**Property Location:** 506 S. Lahoma Avenue  
Chautauqua Historic District

**COA Request:** (HD Case 15-17) Consideration of a request for a Certificate of Appropriateness for the installation of a garage, concrete paving, a covered patio and an 8-foot connecting fence from rear of house to south property line for property located at 506 S. Lahoma Avenue.

**Applicant:** David Boeck  
922 Schulze Drive, Norman, OK 73069

A 1.0

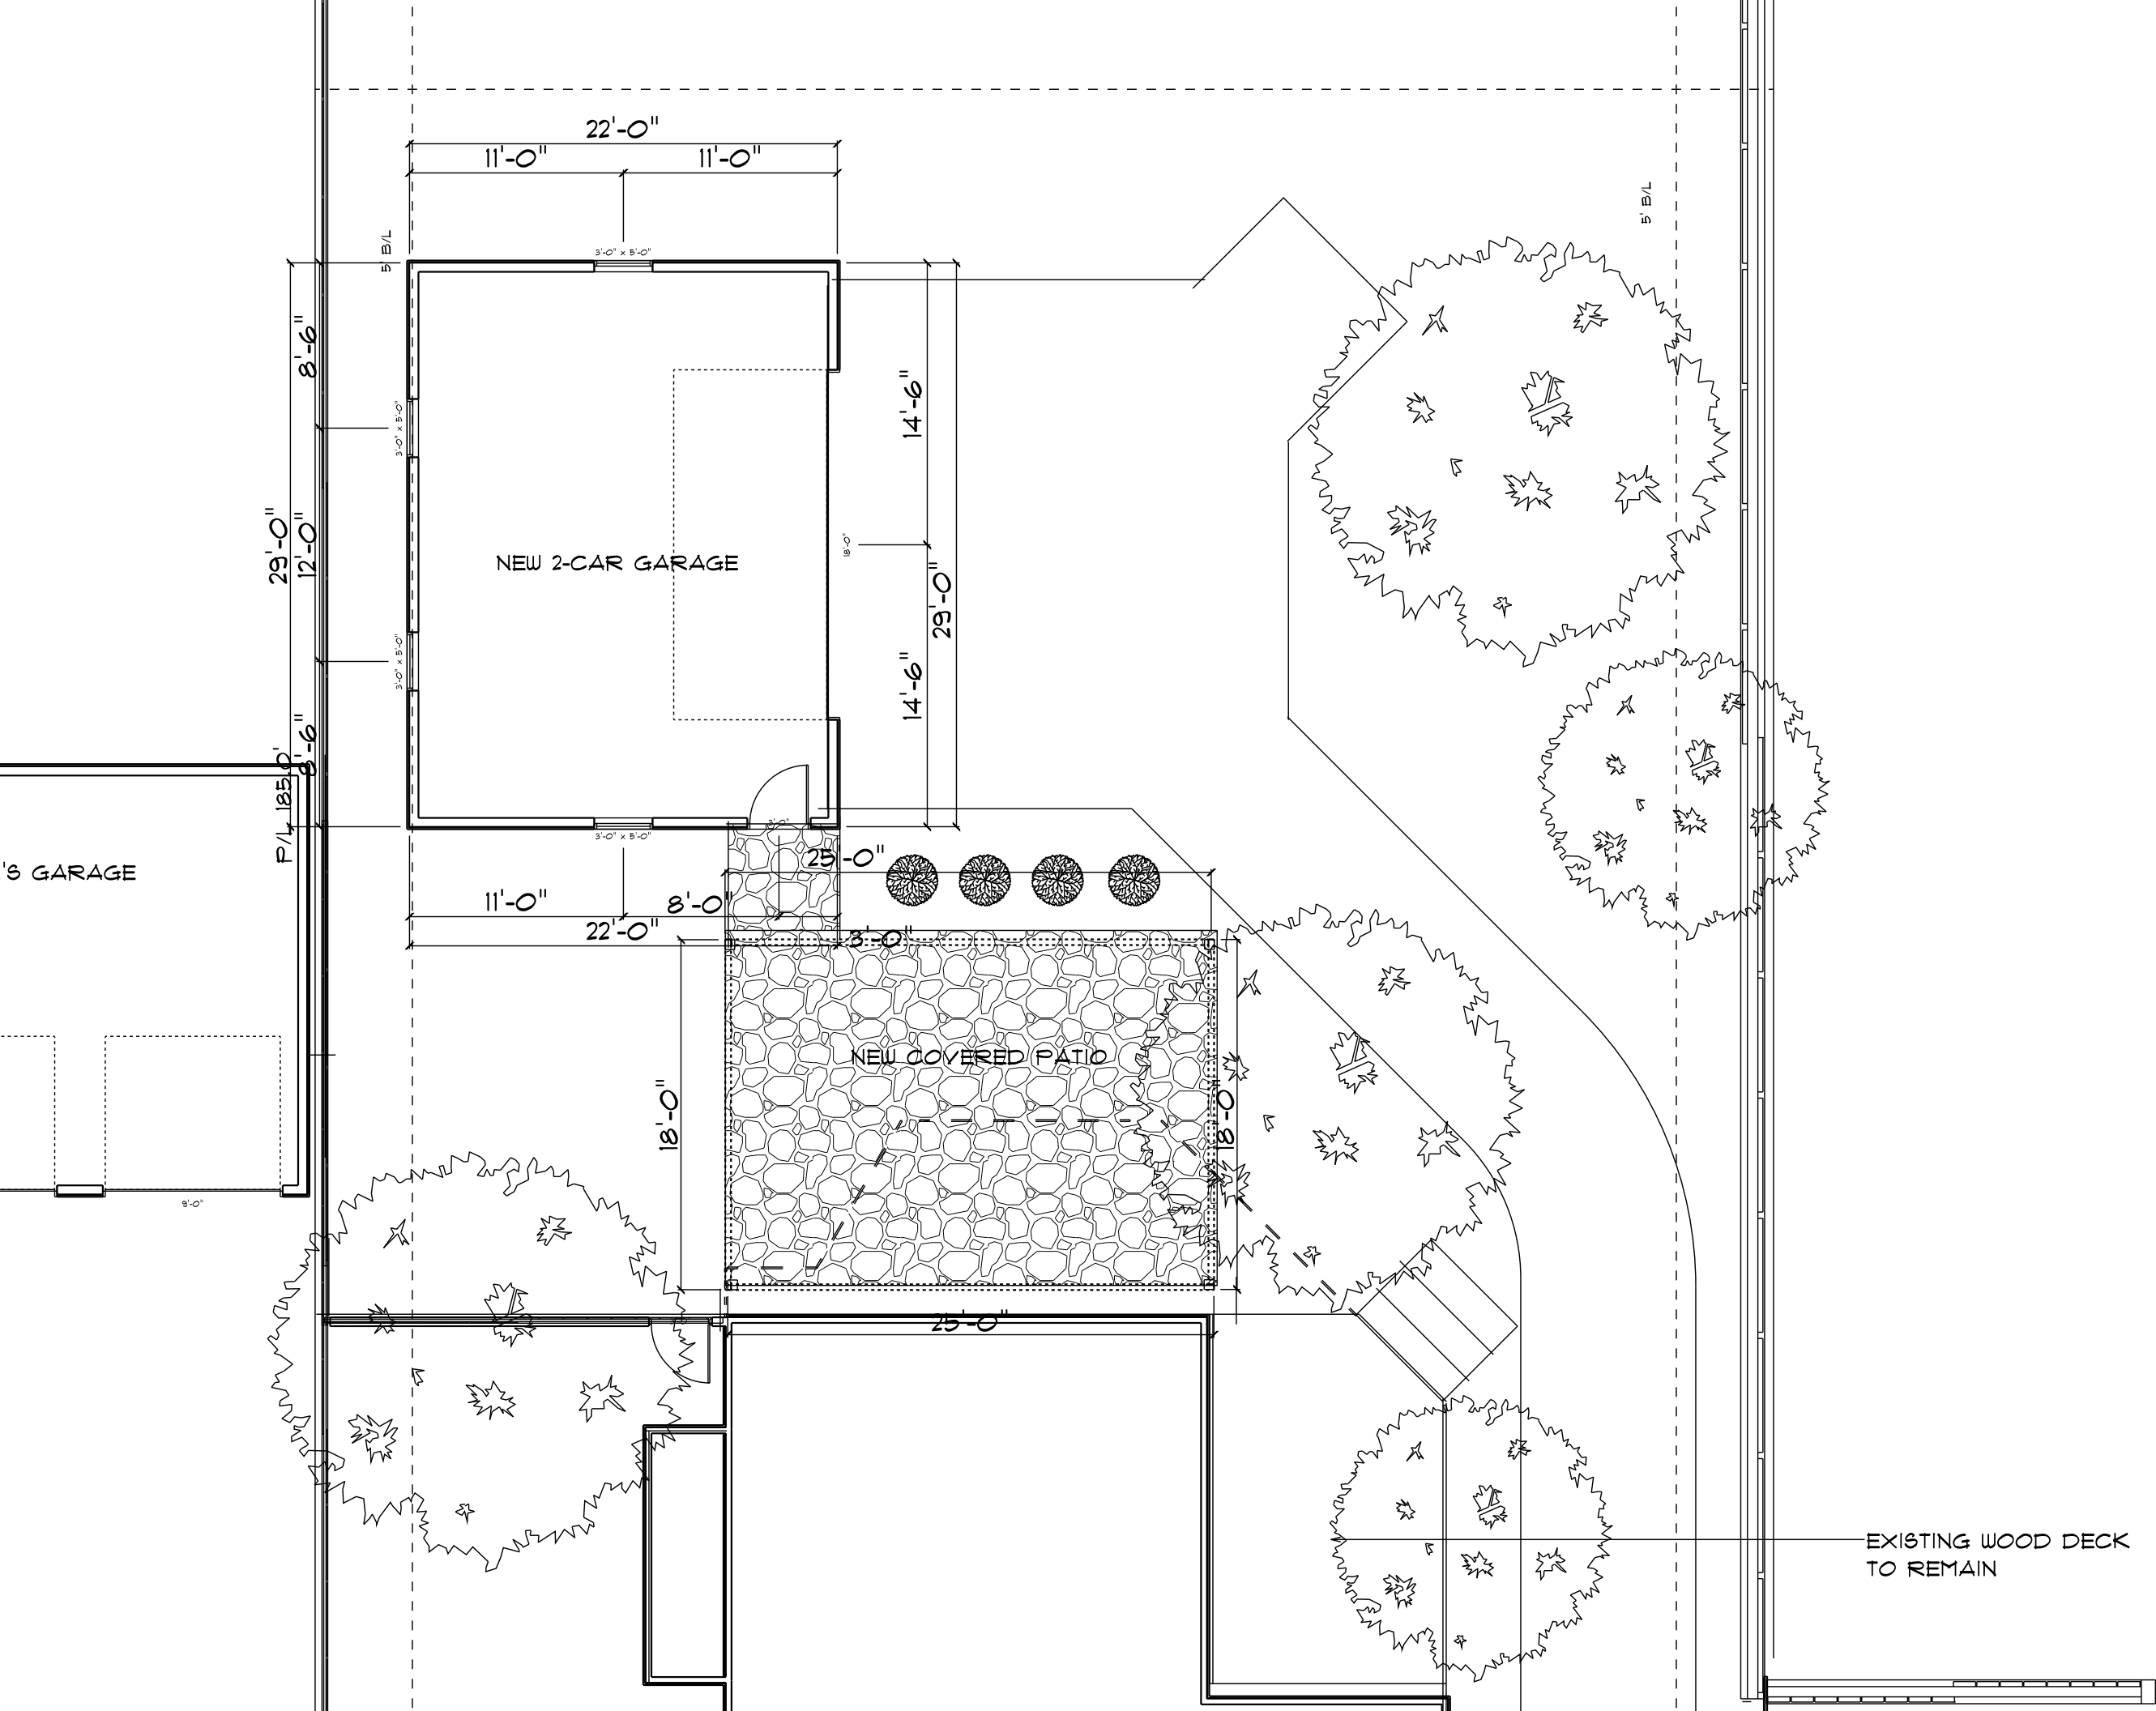
The applicant is proposing a 638 square foot gabled roof garage of similar style as the existing primary structure. David Boeck, on behalf of the owners, has drawn two site plans to illustrate the two possible locations for the proposed garage. The applicant did this at the request of staff since the suggestion from the Commission regarding location was not definitive at last month's meeting. The owner's preferred location, Plan 1, is along the south side of the existing parking pad with the back facing the south property line. This allows for the utilization of the existing parking pad and requires no additional paving to be installed.

The second location illustrated would place the garage along the north property line at the end of the driveway. This location would require the removal of two substantial trees, removal of an existing berm, removal of existing parking pad and re-installation of concrete parking pad.

If the garage location in Plan 1 is approved, no additional paving is required since the existing parking pad would be utilized. The existing parking pad would allow for turnaround room for vehicles. This location does not abut the principal structure nor significantly alter site topography. Since the parking pad has existed in the current location for close to twenty years and no additional paving is required, this paving does not overwhelm the landscape character of the backyard.

The garage location in Plan 2 has essentially the same square footage as the existing concrete pad, however, it would require the removal of the existing parking pad and the re-installation of new concrete pad in a slightly different location and configuration than currently exists. In addition, the Plan 2 location would require the removal of an existing berm, fence structure and two large trees. As noted above from the Historic Preservation Handbook discourages the significant alterations to the site for new paved areas, such as proposed in Plan 2. This proposed location will be more detrimental to the site than the benefits of locating the garage along the property as is traditionally seen in the Chautauqua District.

**Staff Recommendation:** Staff recommends denial of the parking pad re-configuration for Plan 2. No action is needed if Plan 1 is approved.

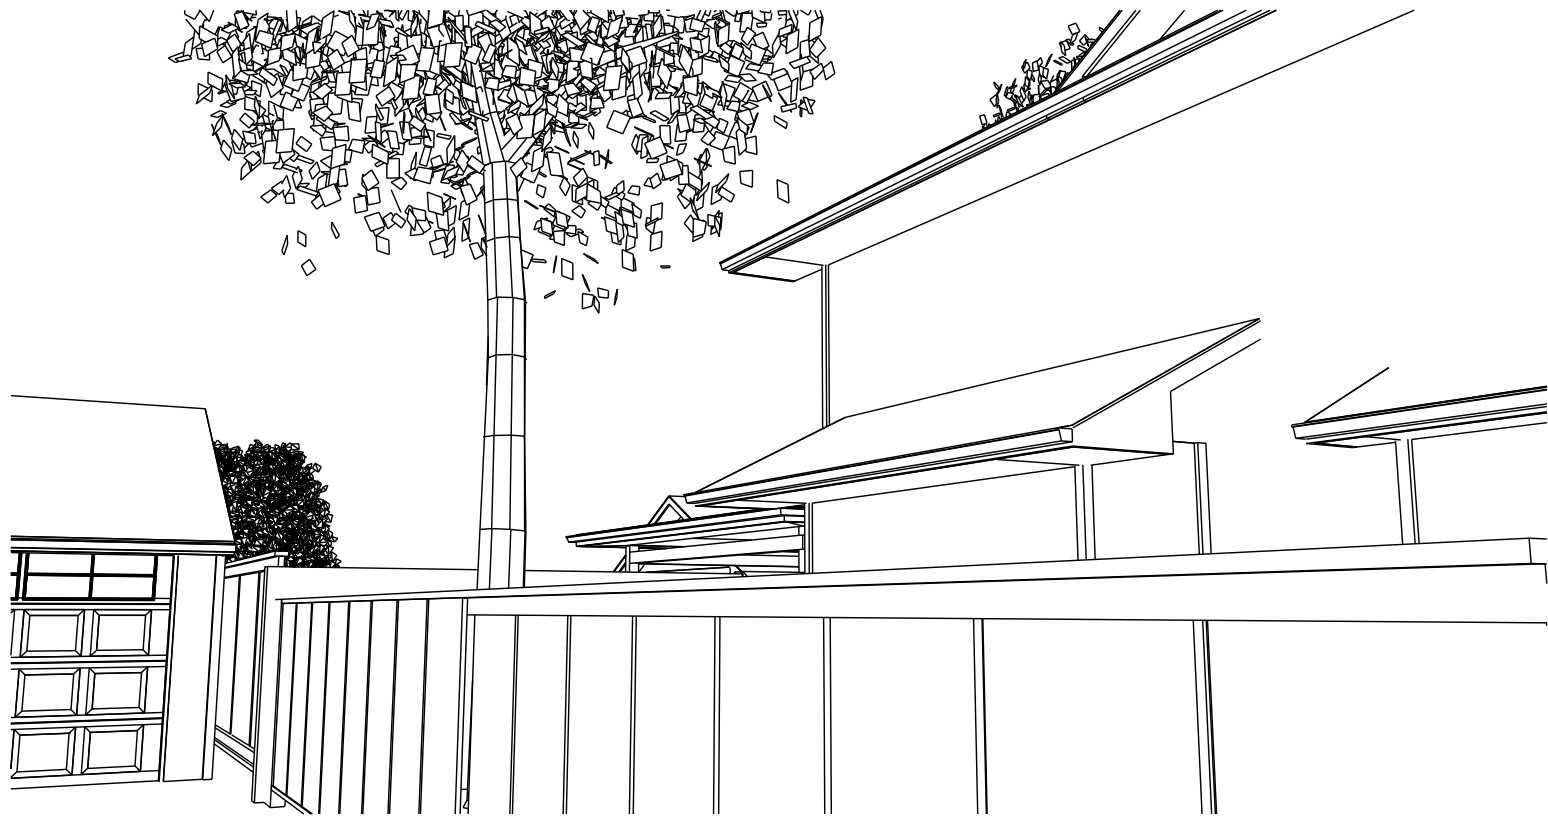
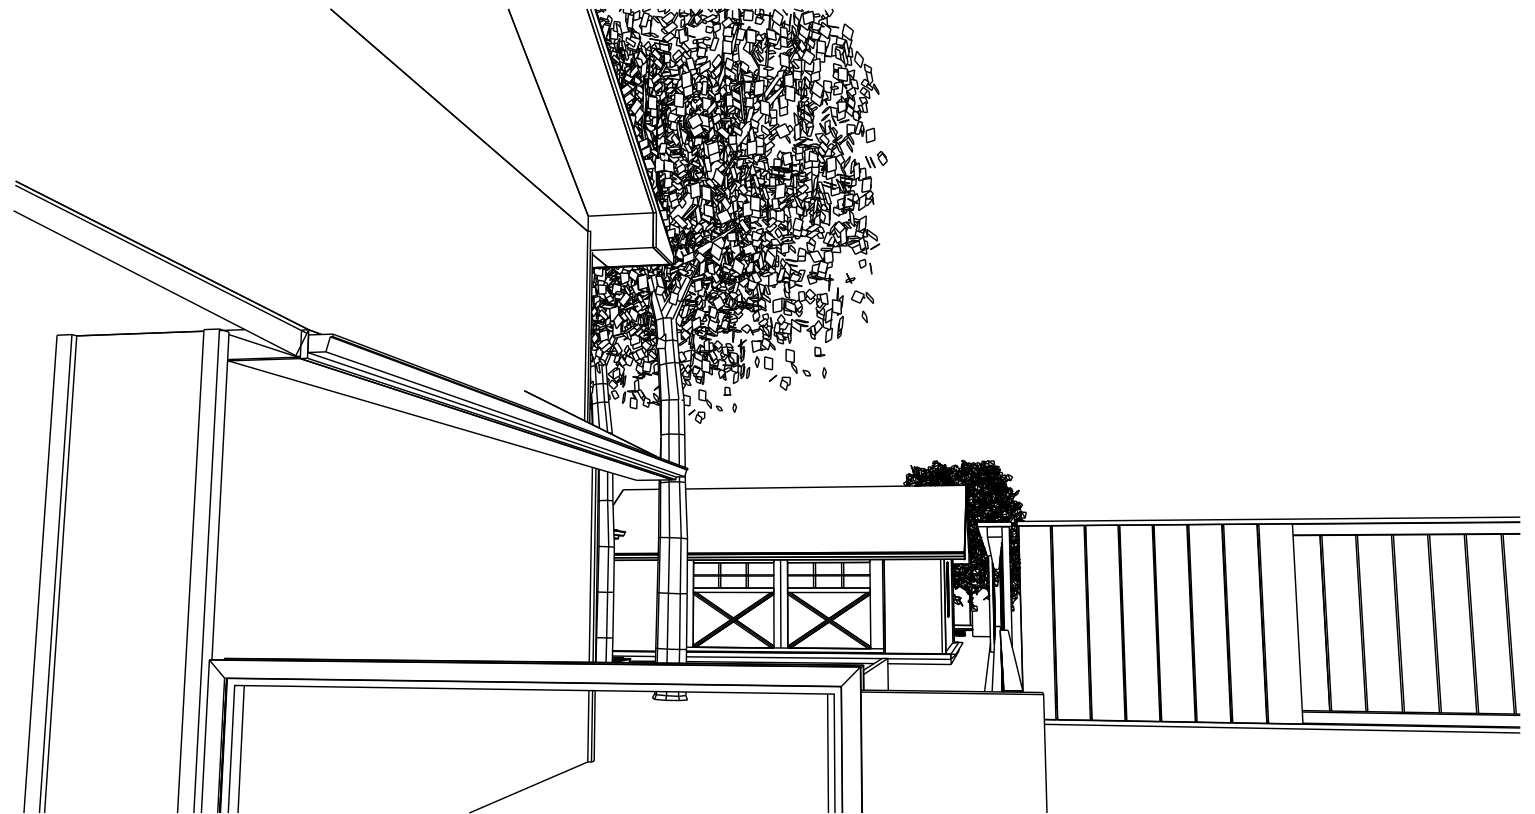
The garage as proposed in Plan 1 will be hidden for the most part by the primary structure. The proposed 8 foot connecting fence as well as existing landscaping will help obscure a clear view of the garage from the front of the house. The applicant has supplied drawings illustrating each proposed garage location from two viewpoints on the sidewalk. According to drawings submitted

by the applicant the view of the structure is limited from the street and sidewalk, but the garage can still be seen from the streetscape view for both Plan 1 and Plan 2.
